2-E-25-HZ
APPLICATION FOR CERTIFICATE OF APPROPRIATENESS

1115 Gratz St. 37917
Fourth and Gill H

Original Print Date: 2/10/2025
 Knoxville/Knox County Planning -- Historic Zoning Commission

Removal of the original rear (left side) entrance and screen door. Applicant states the house has settled, rendering the door inoperable. Installation of a new 12" wide by 72" long, wood, fixed window in its place. In-kind brick will be installed to enclose the remainder of the original door opening.

view from driveway

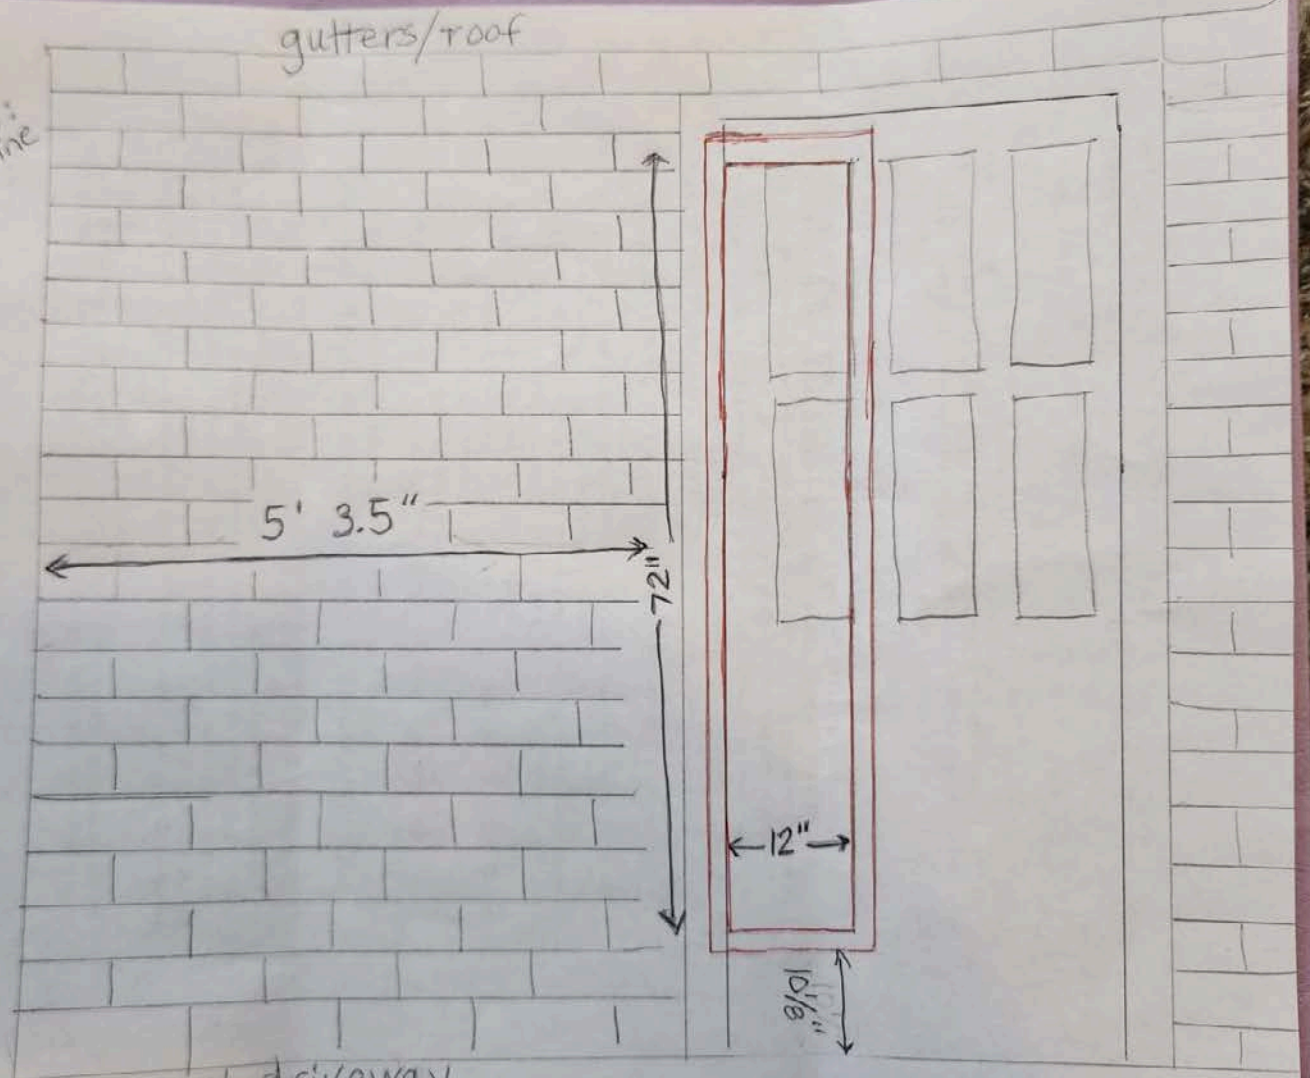
3. Guidelines recommend that additional windows on secondary elevations be compatible with the overall design of the building. The proposed window to be installed is compatible with the original house in materials (a glass window with a wood frame) but the long, narrow (12" wide by 72" tall) window is not compatible with the Craftsman-style house. The proposed window type may be more compatible with a Ranch or contemporary design. A more compatible window may be one that is similar in size and design to the six-light opening on the existing/historic door, or a 6/6 double-hung wood window similar to the house.

Staff recommends approval of Certificate 2-E-25-HZ, subject to the following condition: 1) selection of a new window more compatible in size and design with the overall design of the building, to be submitted to staff for review.
